PCN Title: Change TO263AB Carrier Tape Pitch for Select Discrete Products

PRODUCT CHANGE NOTICE

PCN-2606 REV 1

EMBOSED CARRIER TAPE SPECIFICATIONS

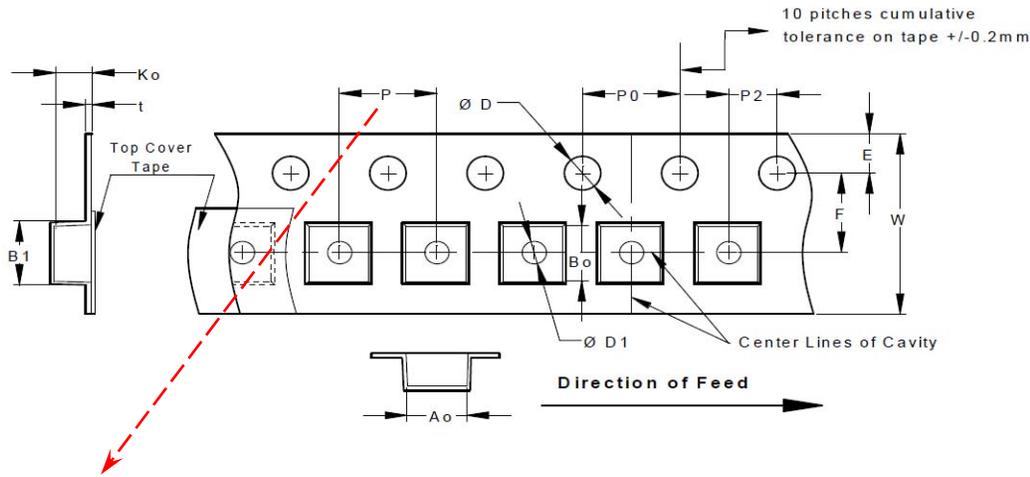
This PCN is being issued to notify customers that Diodes Incorporated is standardizing TO263AB carrier tape pitch (P) from 12mm to 16mm at FBRE (Foshan Blue Rocket Electronics Co., Ltd.), its subcontracted assembly and test site for select discrete products listed below. Please refer to the drawing and table below for details concerning this change.

Dimension	Before Change	After Change
P	12mm	16mm
